REMARKS/ARGUMENTS

Appl. No. 10/608,684

Amdt. A dated December 9, 2004

Reply to O.A. of September 9, 2004

FIG. 2

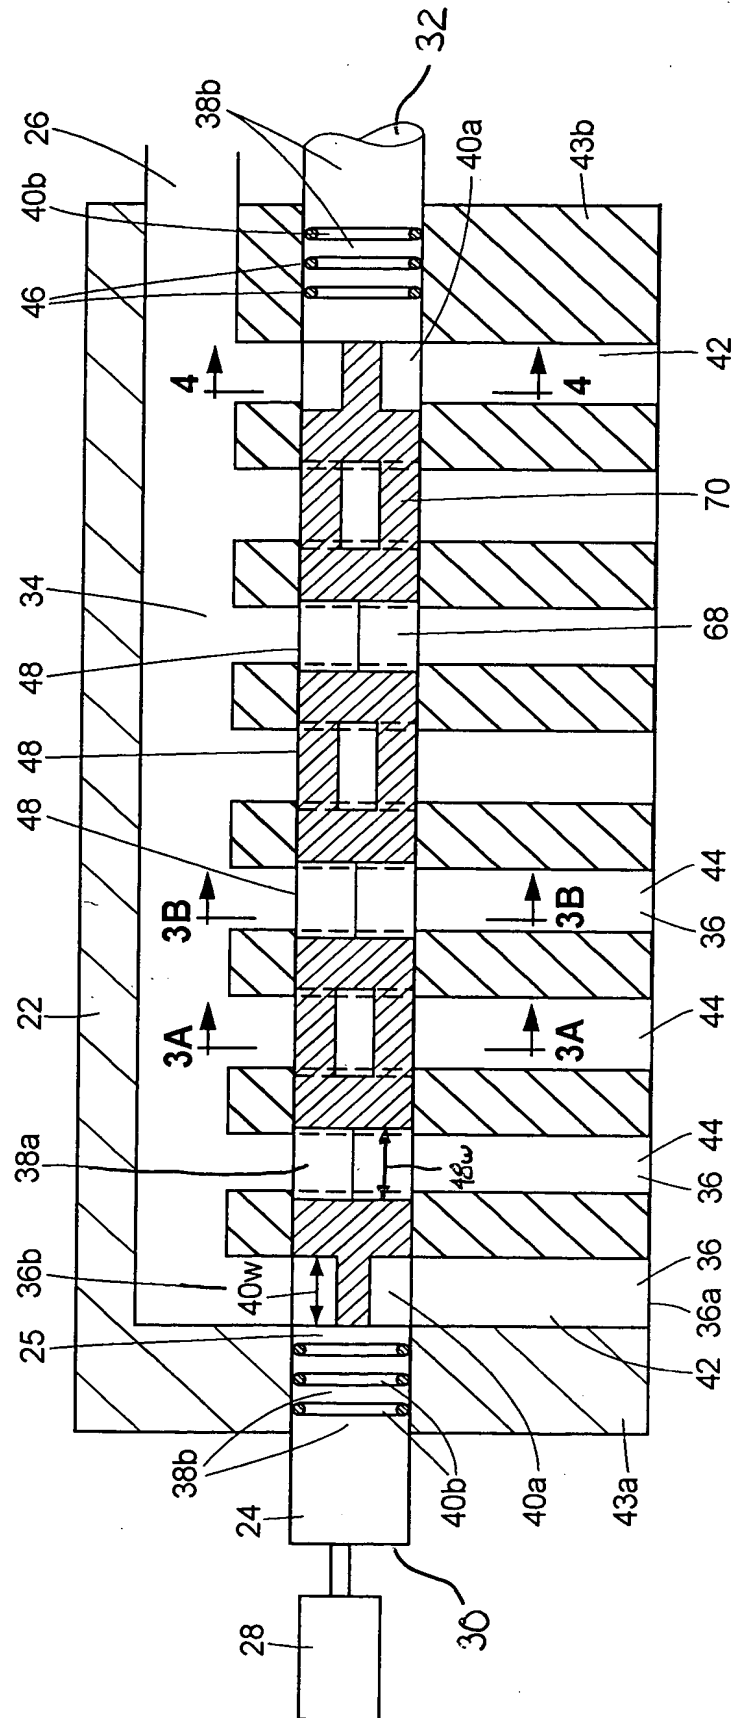
In Figure 2, reference numbers 30 and 32, with appropriate lead lines indicating the opposite ends of the valve element, and reference number 48w and dimension indicator, with an appropriate lead line indicating the width dimension of the apertured sections, have been added in accordance with the usage thereof in the original specification:

The remaining amendments to Figure 2 (extending the lead lines of reference numerals 36b and 38a) and Figure 3B (changing reference numeral 50a to 50c) correct inadvertent differences between the drawings as originally filed and the formal drawings filed on July 14, 2004. These amendments do not add new matter or present a change from the drawings as originally filed. Therefore, the undersigned respectfully requests the examiner to enter these amendments to the formal drawings.
